# SITE PLAN WITH ADJUSTMENTS

# 2252 TOWER ROAD

### COVER SHEET

1 LANDSCAPE PLAN Drawing North SCALE: 1"=20' 0' 10' 20' 40'

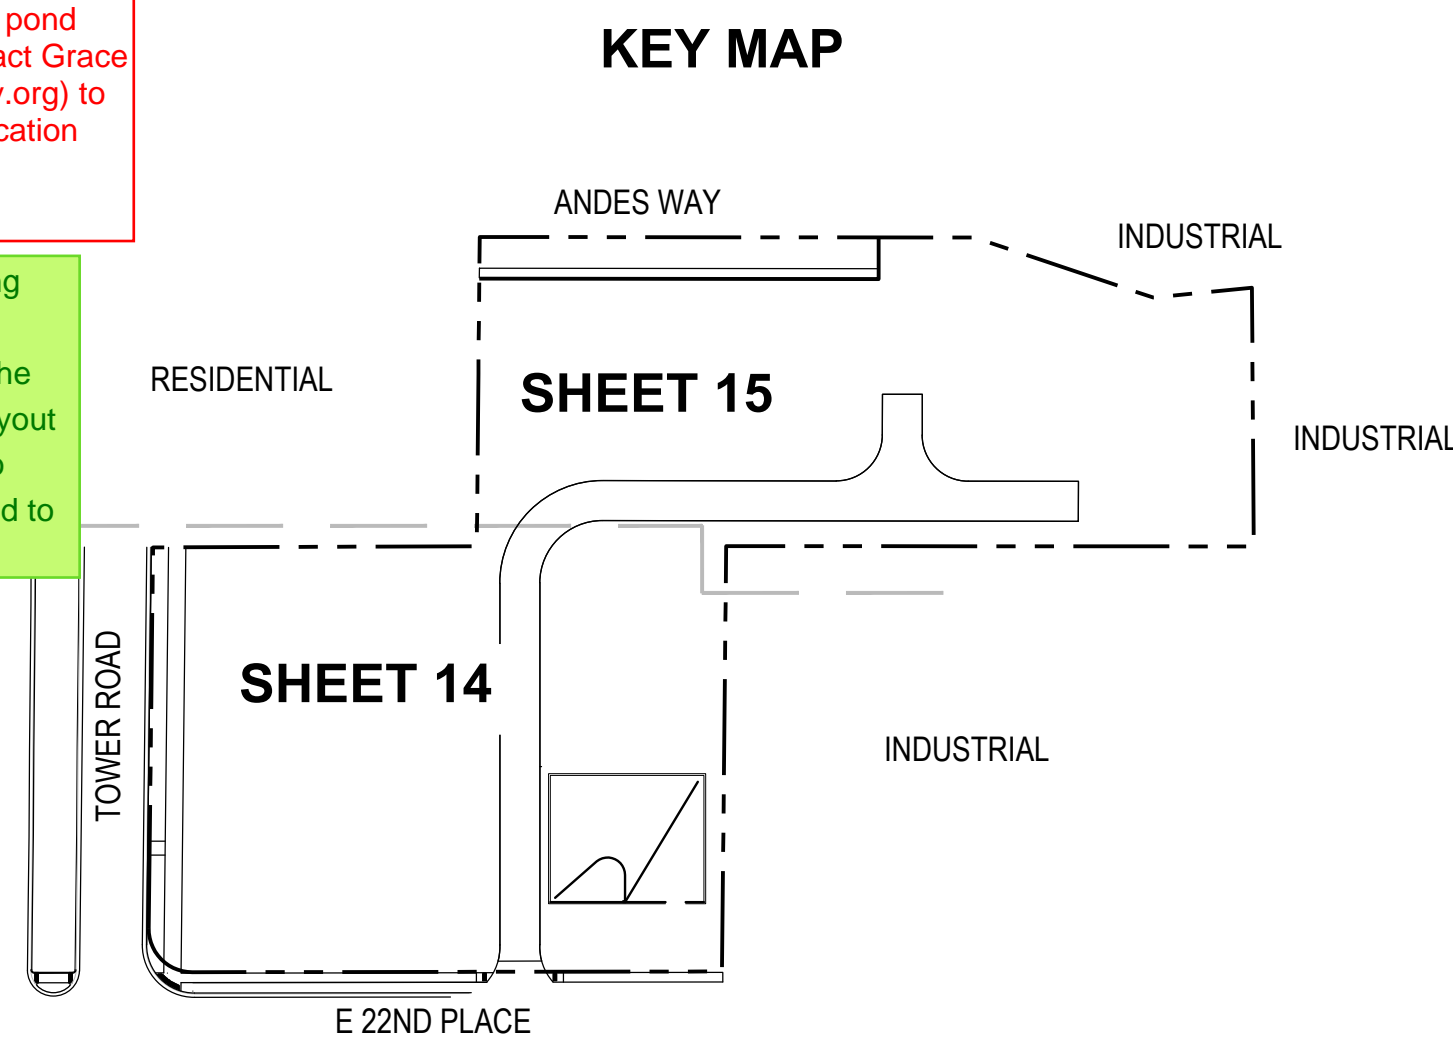
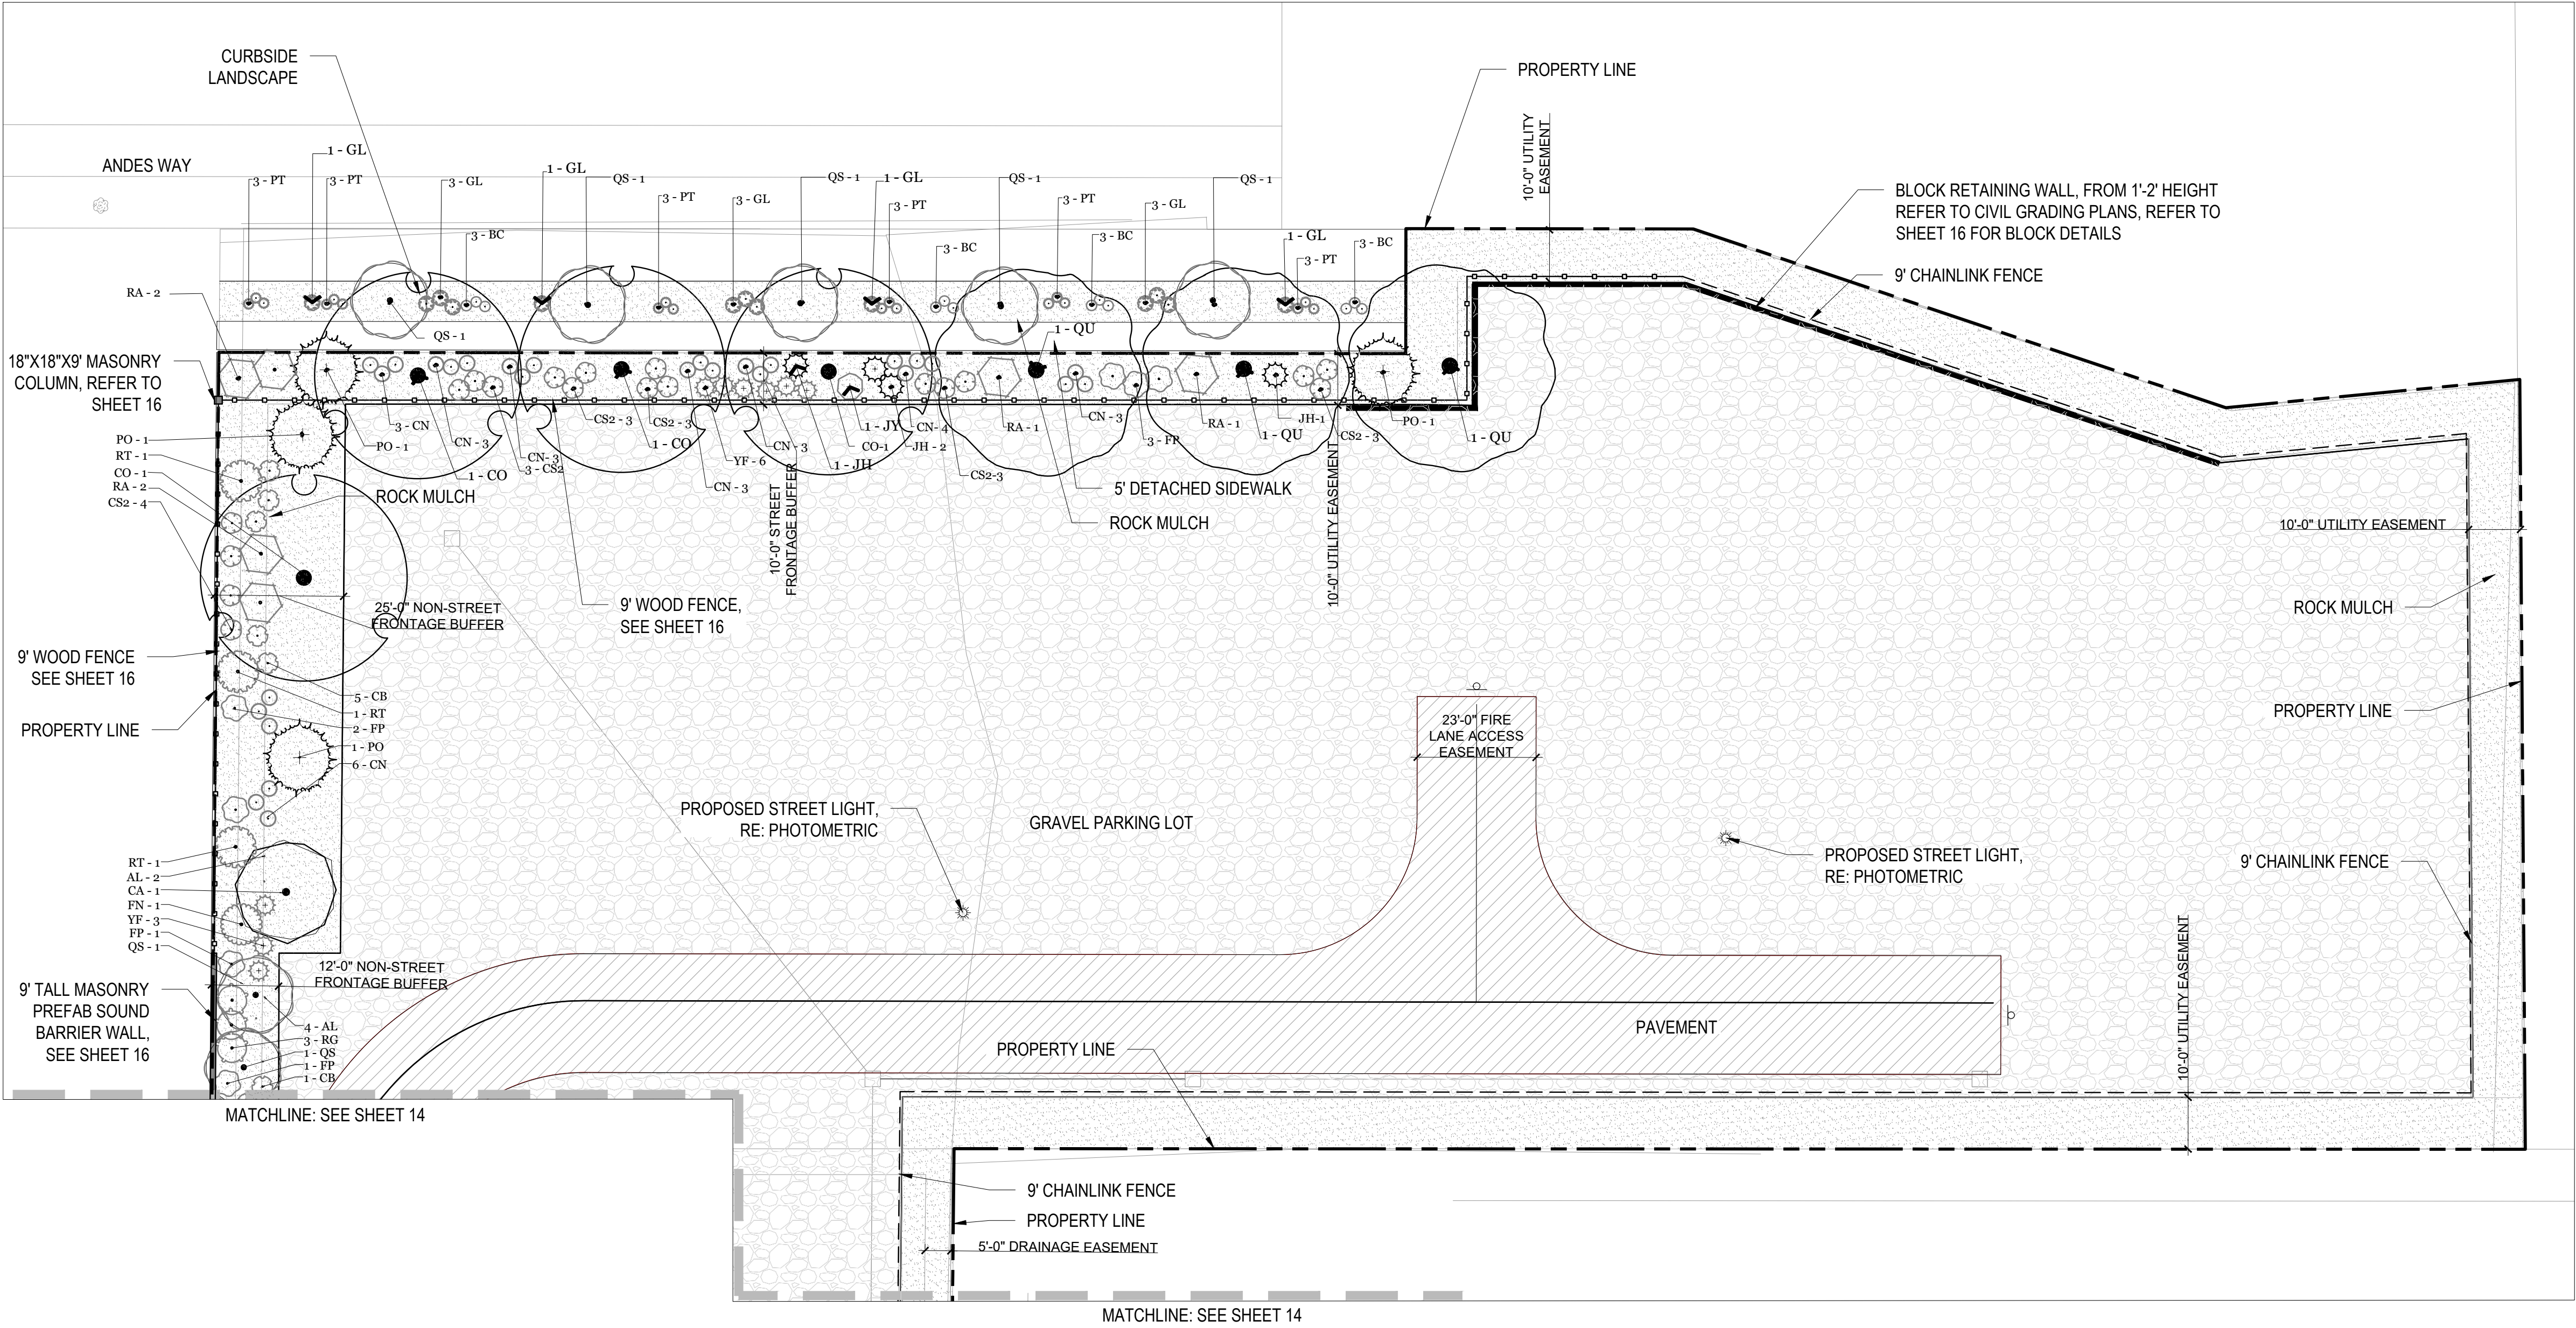
Discuss with your PDR reviewer if maintenance access and access easement to the pond must be provided. Contact Grace Gray (ggray@auroragov.org) to start the easement dedication process if necessary

**RESPONSE:** Conforming access ramp has been added to the plans per the civil engineer. Fence layout has been re-designed to allow access to pond and to keep site secure.

RESPONSE: Fence linetype updated. Fence height is called out on plan and in legend.

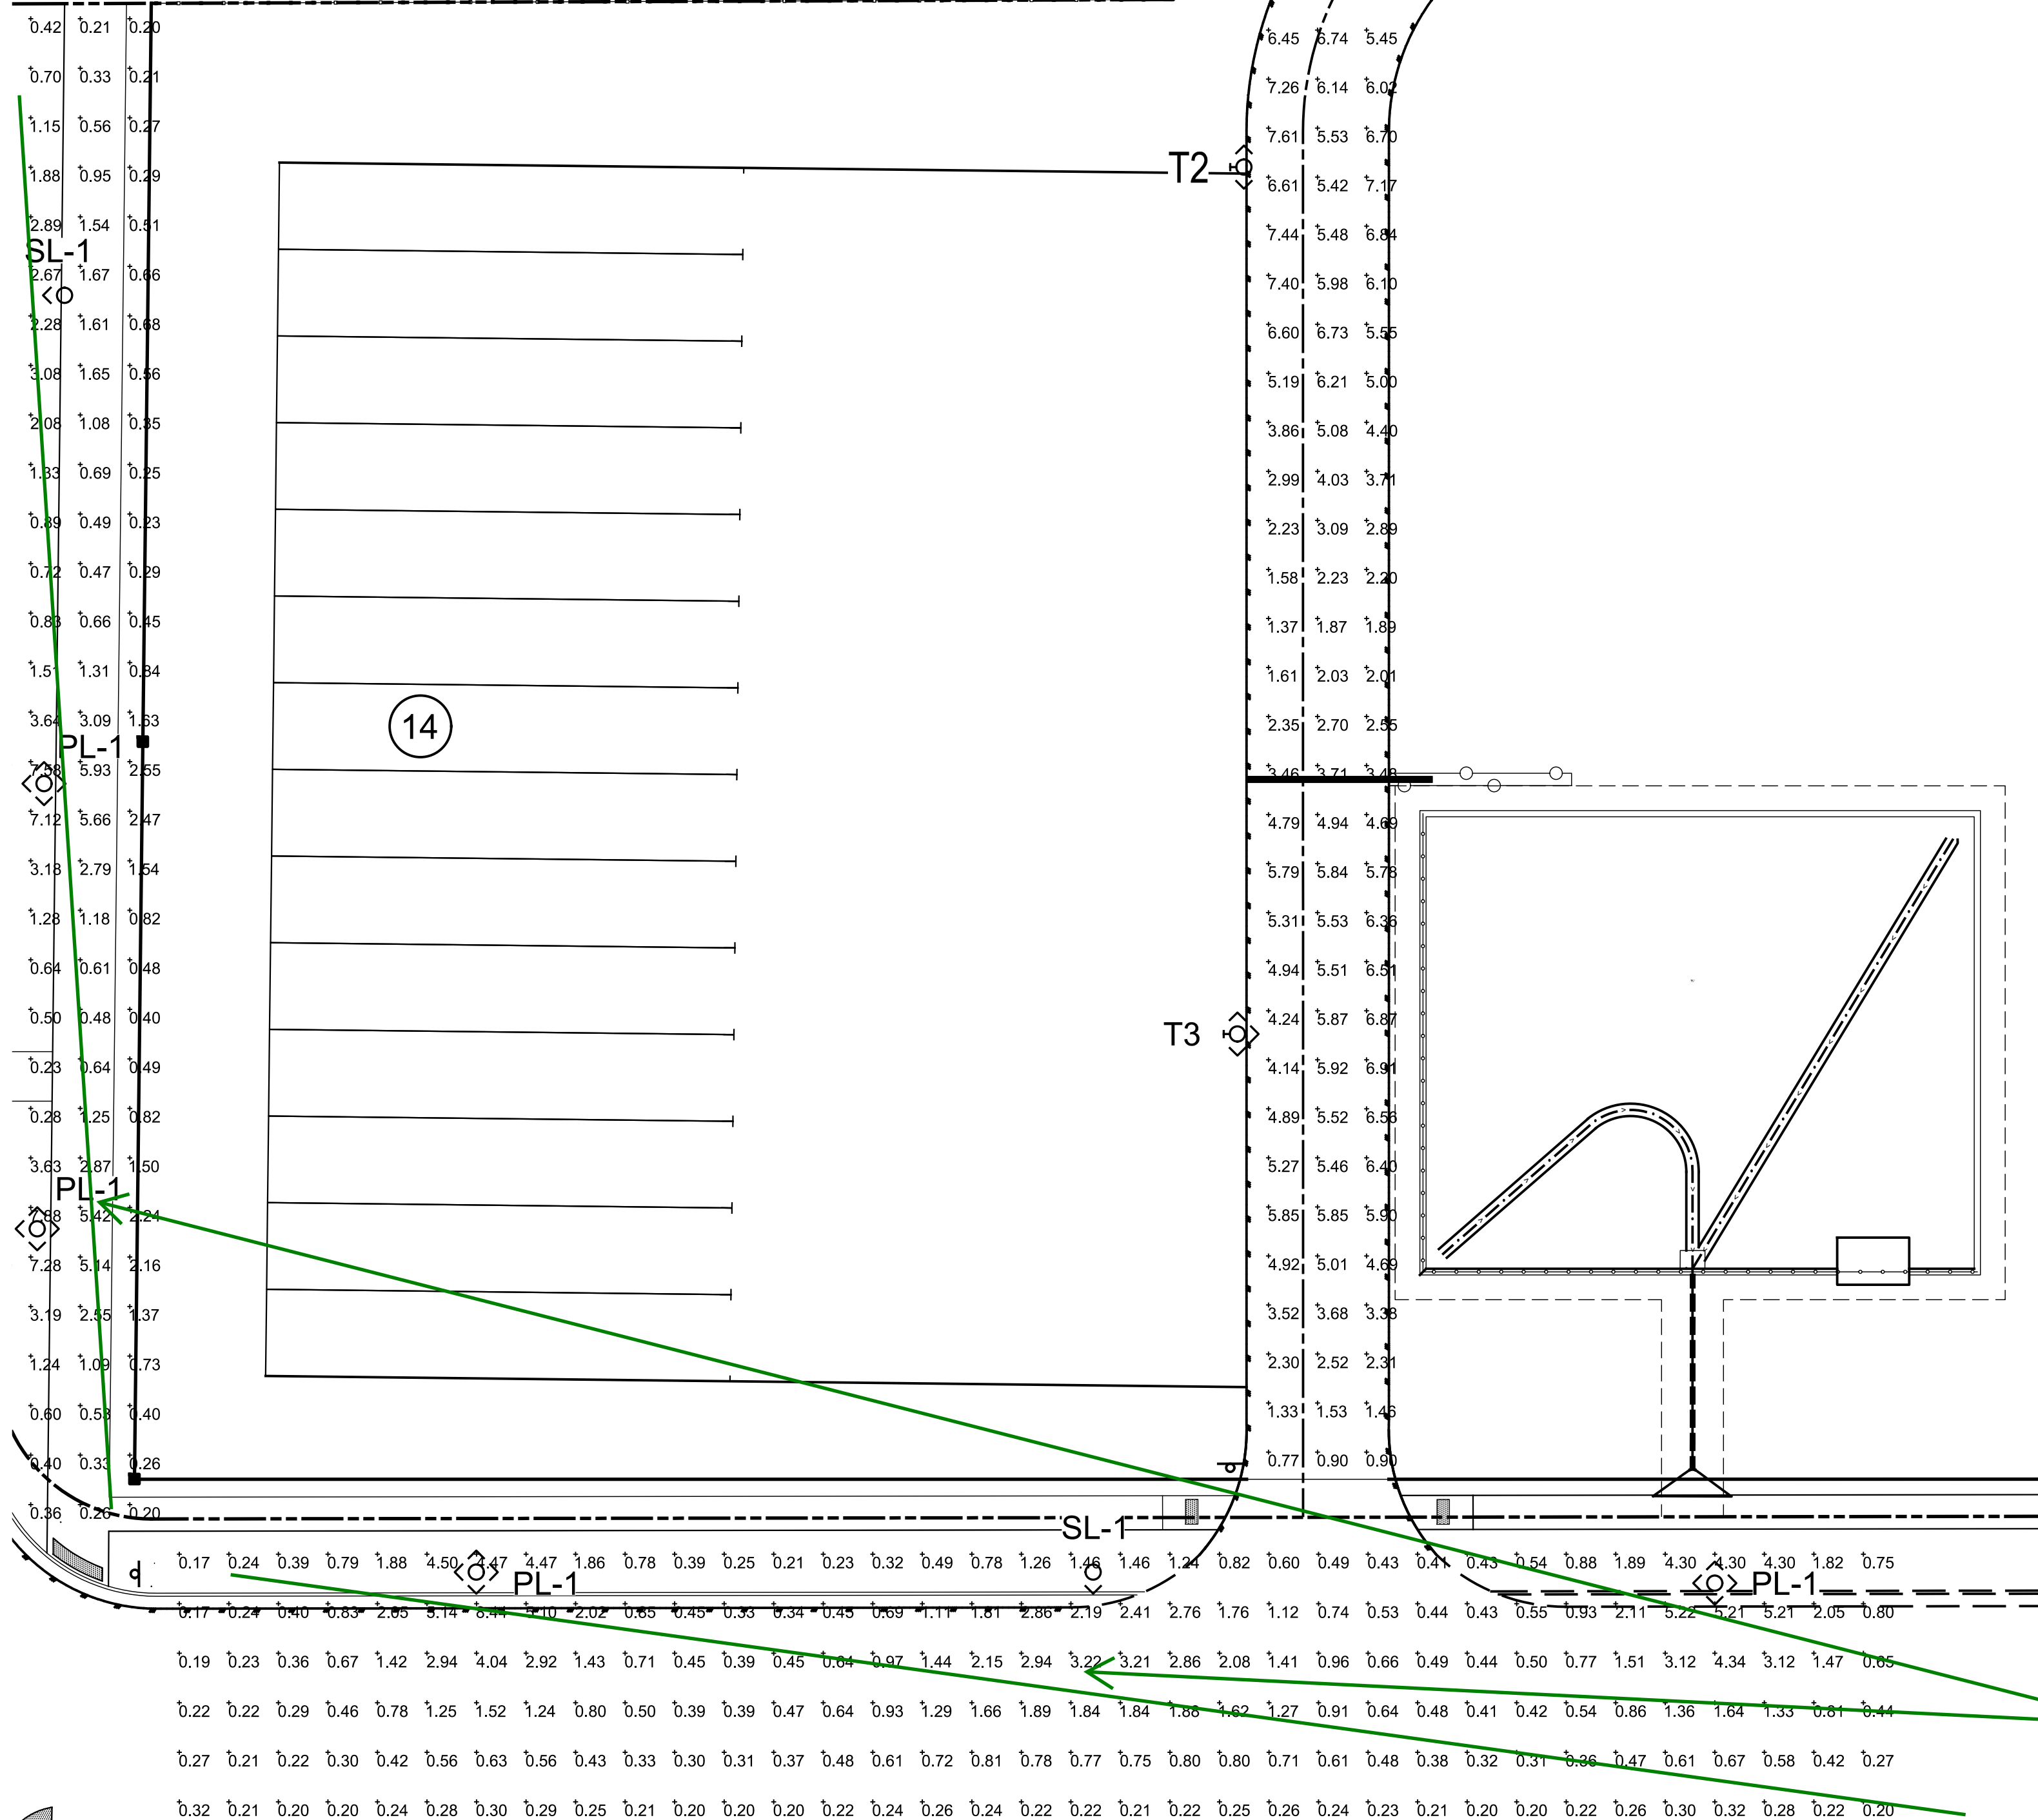
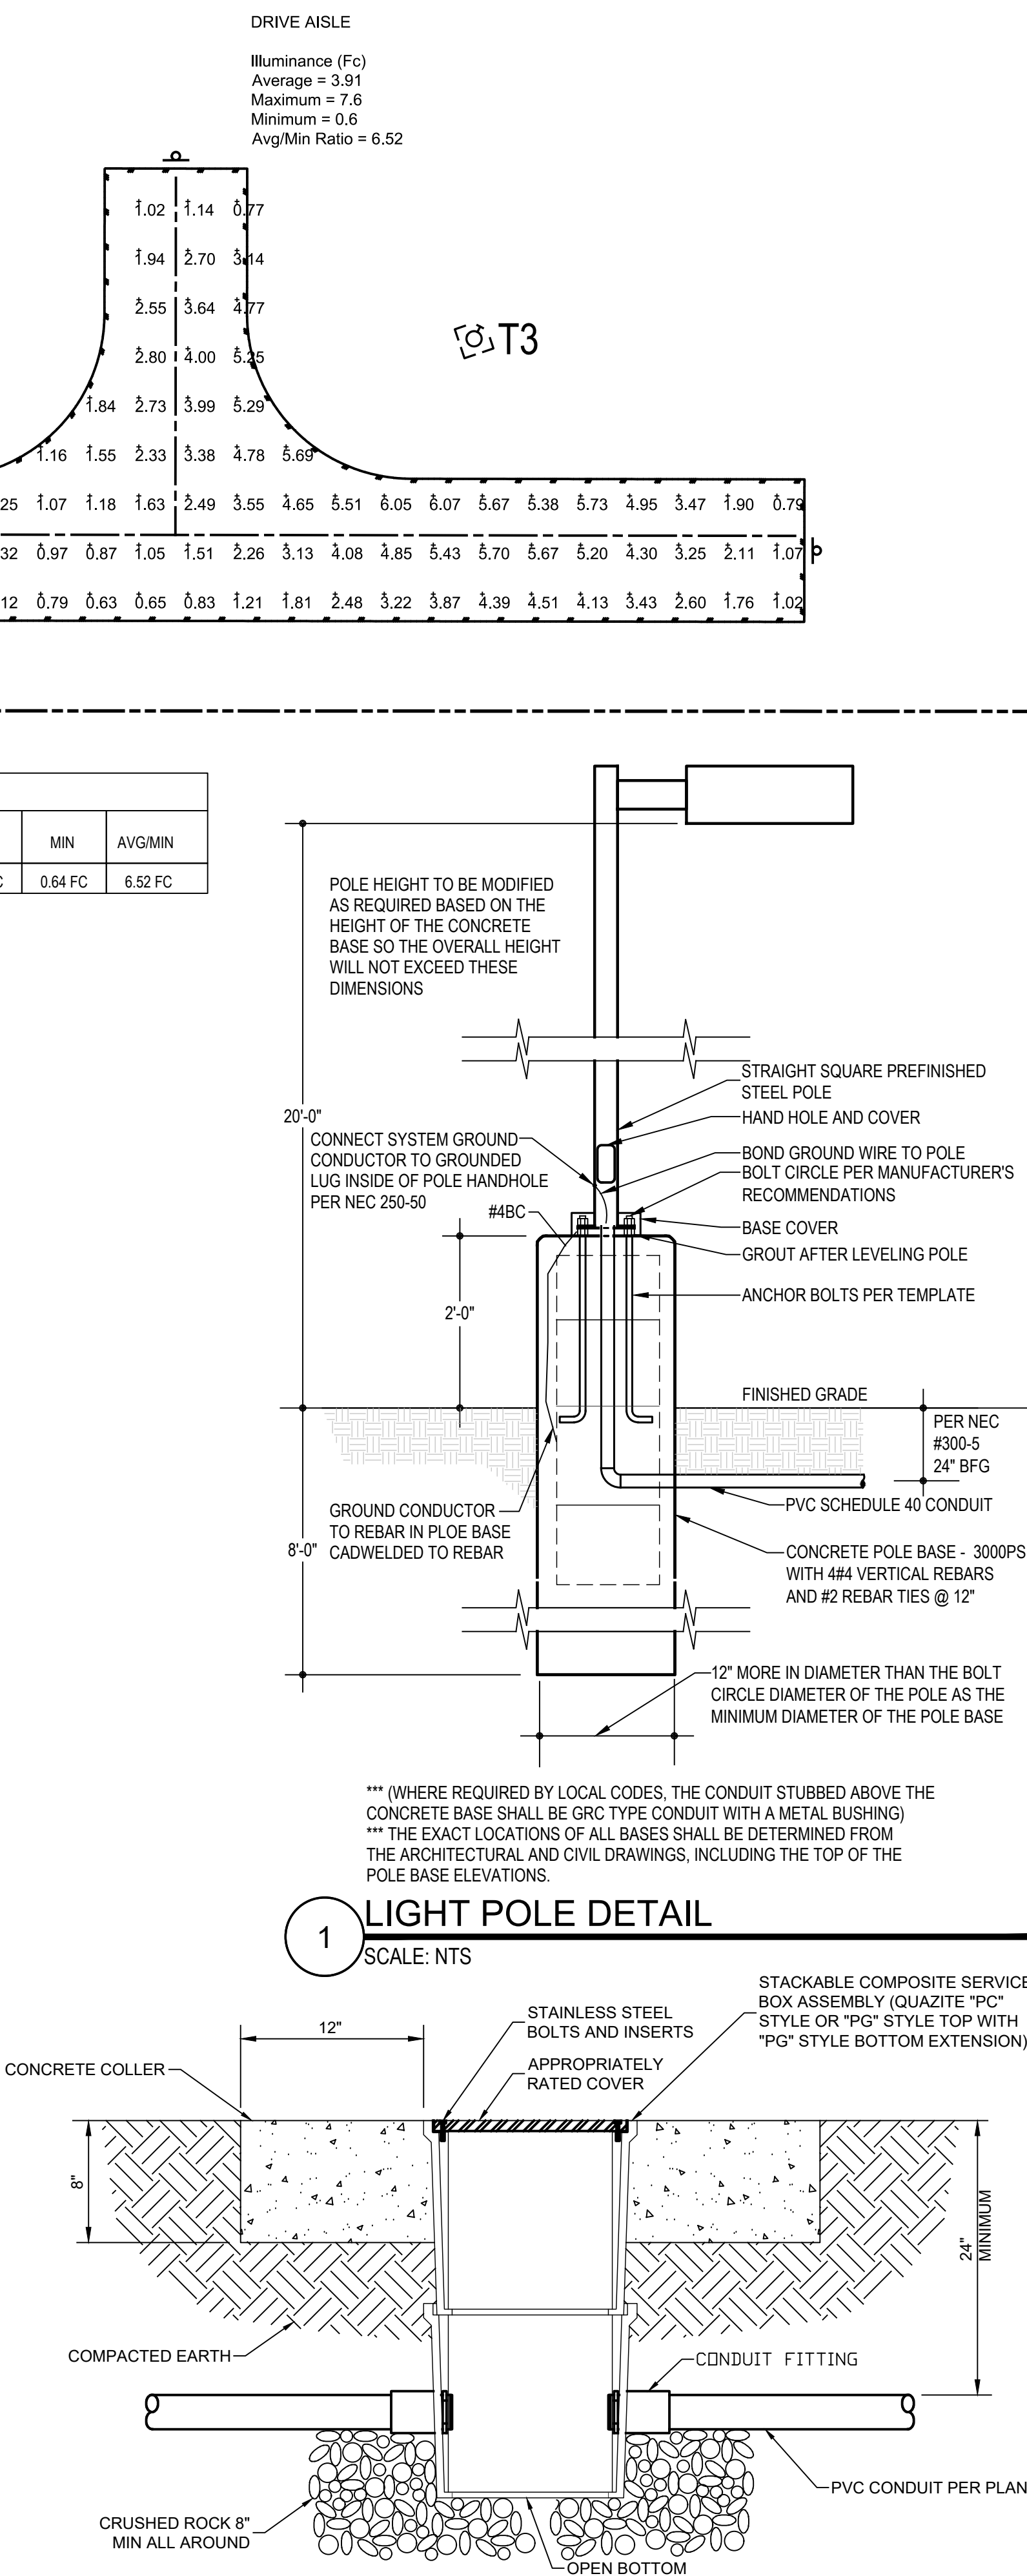
New comment based on new information:

Please only include this level of photometric detail on the civil plan submittal for the public street and ped lights, and not the site plan, typ. ALL

9L. New comment based on new information: Please only include this level of photometric detail on the civil plan submittal for the public street and ped lights, and not the site plan, typical all.
